CALIFORNIA CROSSROADS

Stage 2 Road Safety Audit

REPORT NUMBER: 70068199/RSA2/1/1

DATE: MARCH 2023

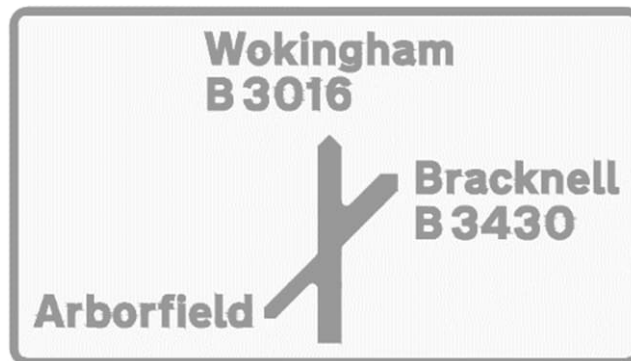
Map-type advance direction traffic signs in the format shown below will be provided on all approaches to the California Crossroads junction. It is considered by the Stage 2 Road Safety Audit Team that these signs could be misleading in relation to the junction layout downstream (i.e. on the sign plate shown below, the thicker lines could imply that straight ahead and right turn movements will have priority at the junction, although the junction layout will not have any movements that have priority over others).

Therefore, this could increase the potential for a road user entering the junction, assuming that they do not need to give-way to other road users, and colliding with another vehicle travelling through the junction. Consequently, it is recommended the proposed map-type advance traffic sign layouts are amended to show an appropriate junction layout design, consistent with the proposed junction layout.

Accepted - A new ADS sign will be added to the proposals for this scheme.

DRAWING NO: 8199-LA-001
REV: C03
© WSP UK Ltd

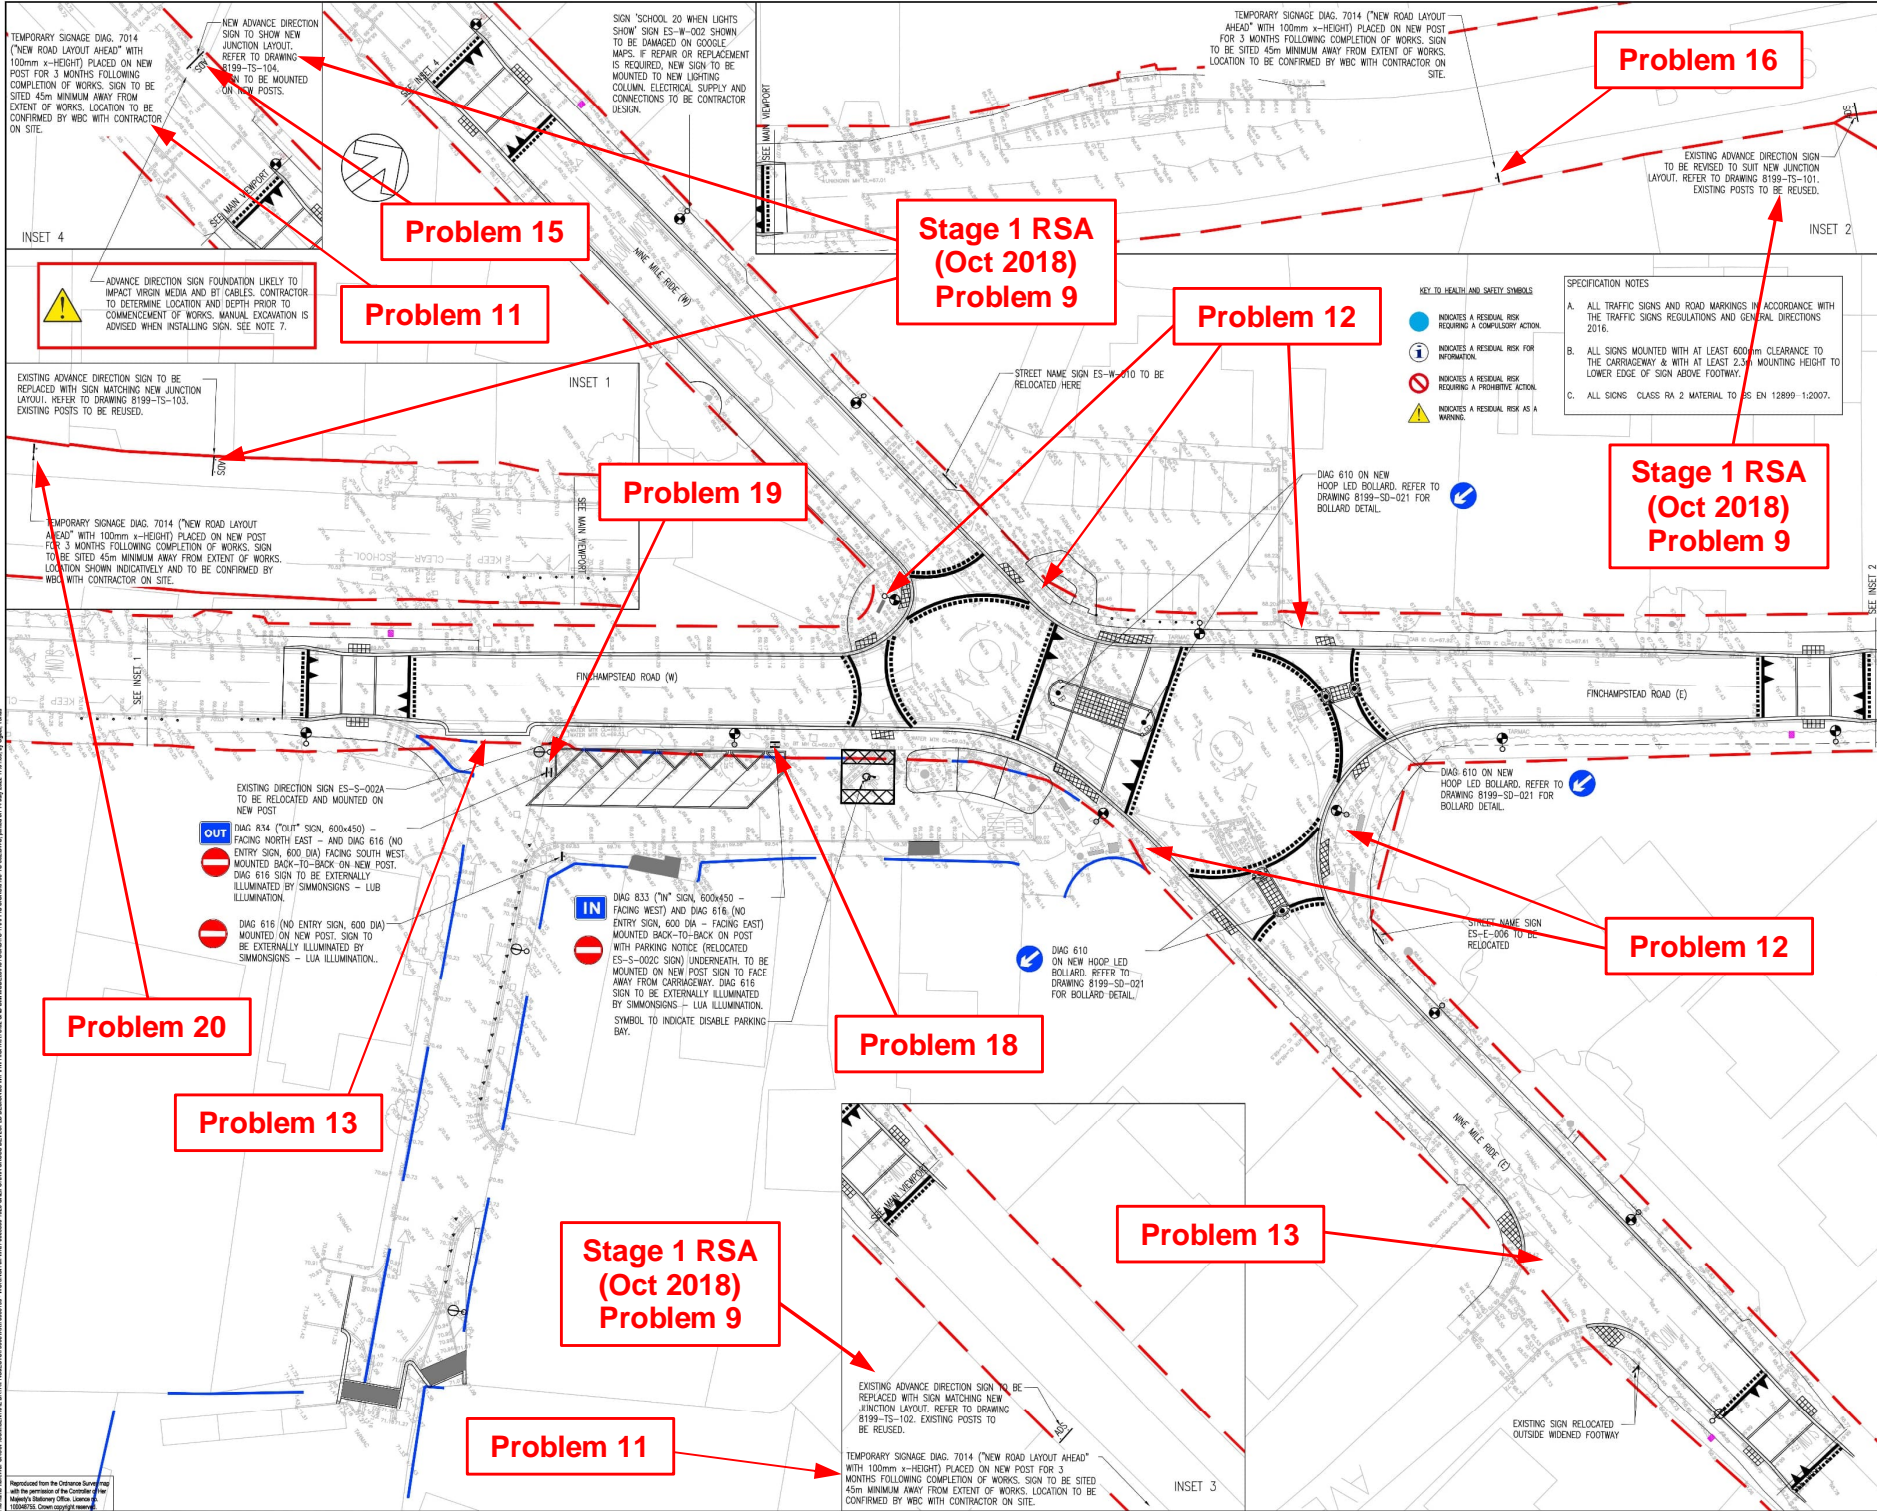
A pedestrian crossing facility will be provided across Finchampstead Road, at the south-western entry of the California Crossroads junction. At the proposed crossing point on the east side of the road, the visibility to the east along Nine Mile Ride could be restricted to approximately 15m by the proposed raised planters and vegetation to be installed adjacent to the crossing point.

It is recommended that the layout / location of the proposed raised planters is amended so that clear adequate visibility of vehicles approaching from the east on Nine Mile Ride is provided from the pedestrian crossing point (located on the east side of the Finchampstead Road south-western arm of the junction).

DRAWING NO: **8199-TS-002**

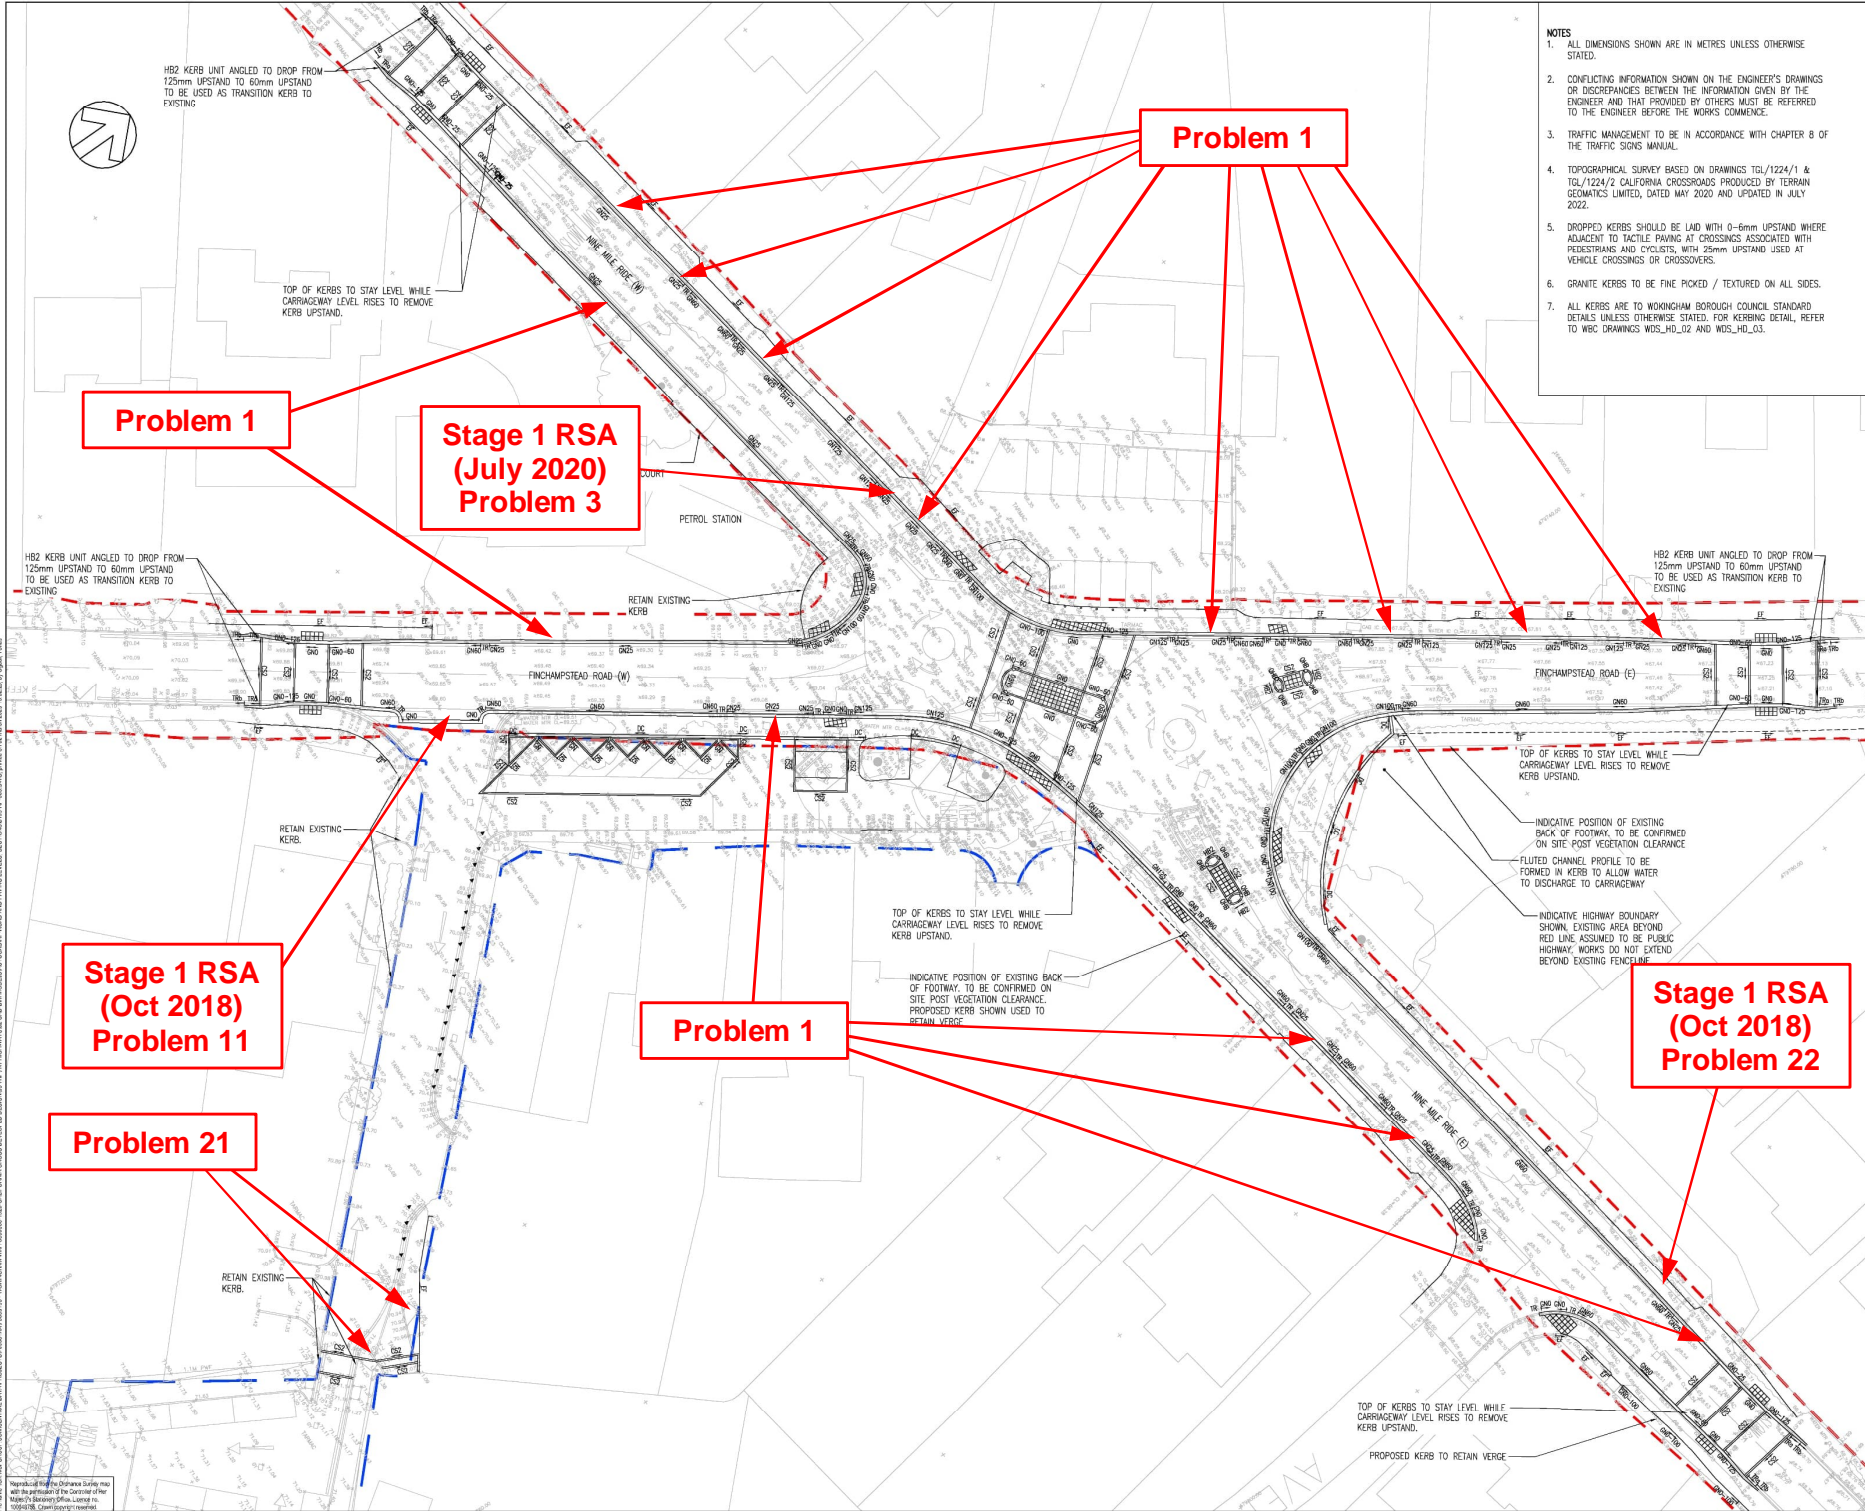
The exact locations of the proposed “New Road Layout Ahead” traffic signs, on the Nine Mile Ride westbound and eastbound approaches to the junction, are unclear from the design drawings (drawing number 8199-TS-002 states that these signs will be installed a minimum of 45m upstream of the scheme extents). These signs could be installed on new sign posts in the centre of the footways, where they will present an obstruction to pedestrians, or they could restrict the visibility of existing traffic signs located adjacent to the proposed signs.

The proposed “New Road Layout Ahead” traffic sign on the Finchampstead Road northbound approach to the junction will be installed in close proximity to the proposed map-type advance direction sign as well as the existing ‘School 20 when lights show’ advance warning traffic sign.

DRAWING NO: 8199-ATR-001 REV: P05

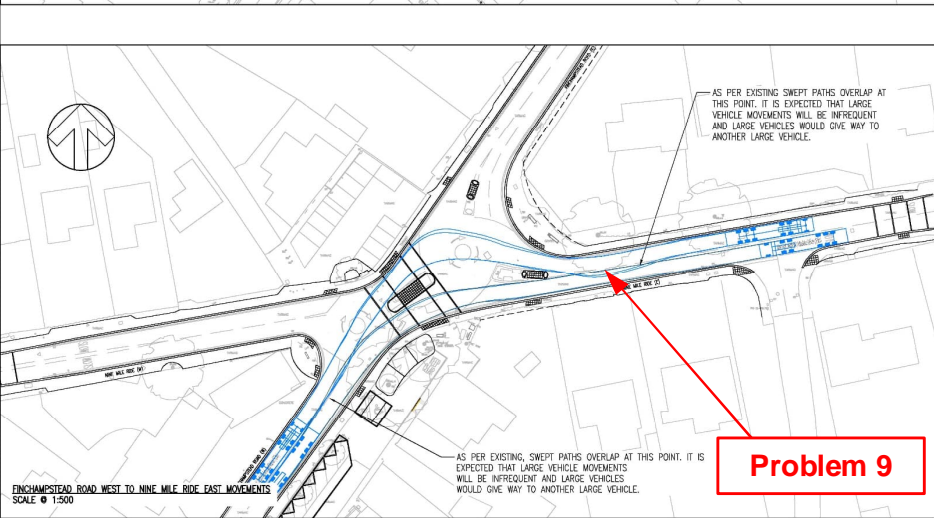
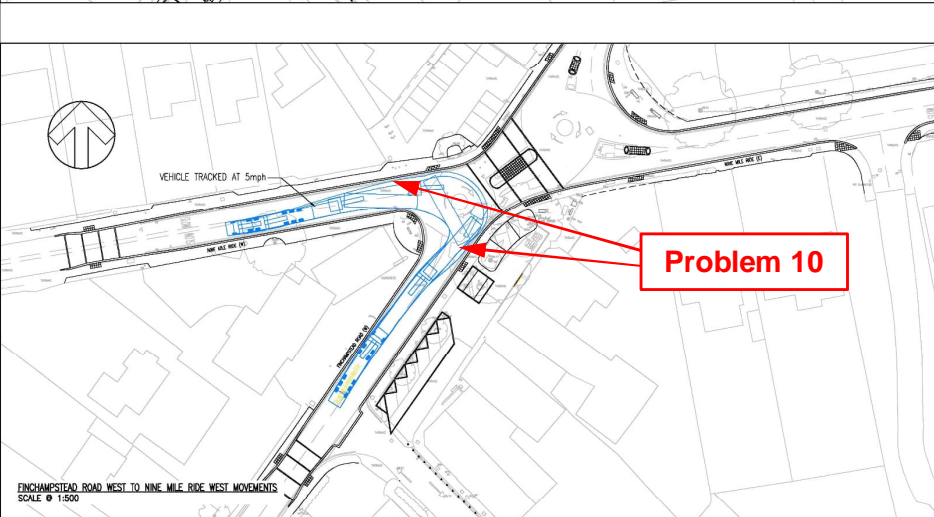
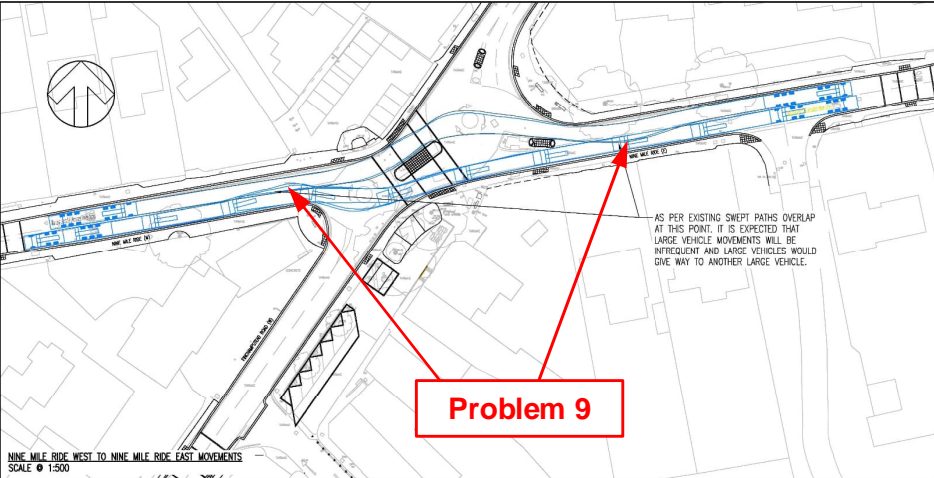
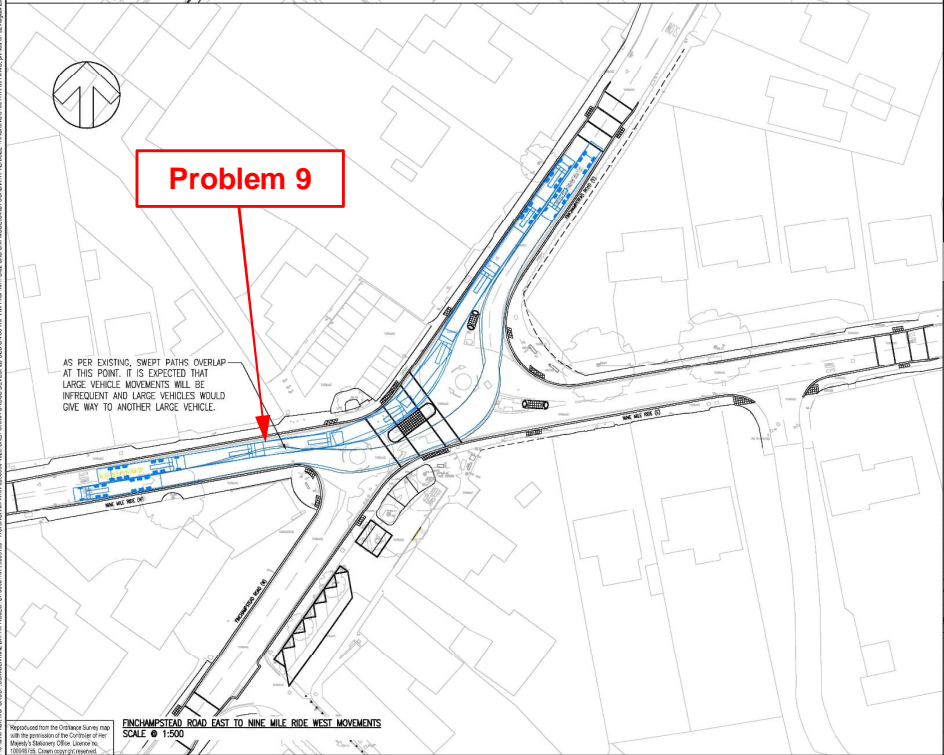
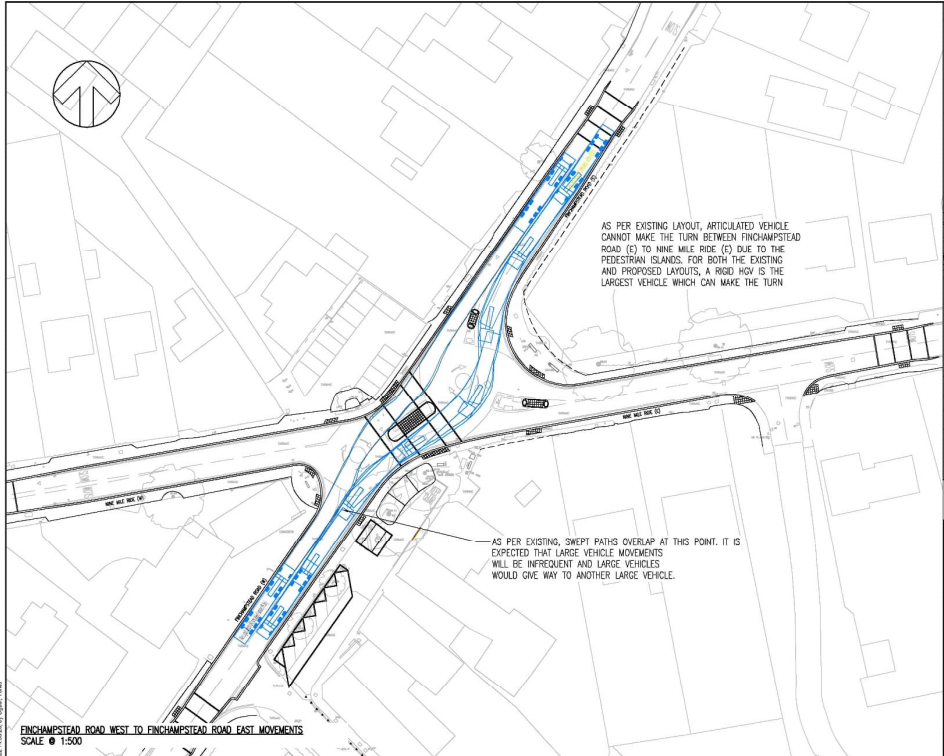
Drawing number 8199-ATR-001 (revision P05) shows the swept paths of 16.5m long articulated vehicles travelling through the proposed junction layout. Several vehicles of this type were observed travelling through the junction during the site visit. These heavy goods vehicles (HGVs) turning onto Nine Mile Ride, travelling westbound and eastbound, are shown to encroach into the opposing traffic lanes used by vehicles approaching the junction. This could increase the potential for a head-on collision between an HGV and a vehicle approaching the junction on Nine Mile Ride.

Drawing number 8199-ATR-001 (revision P05) shows the swept paths of 16.5m long articulated vehicles travelling through the proposed junction layout. These HGVs turning between Nine Mile Ride (West) and Finchampstead Road (South) in both directions will encroach notably into the path of opposing traffic on the approaches / exits at the junction on these arms.
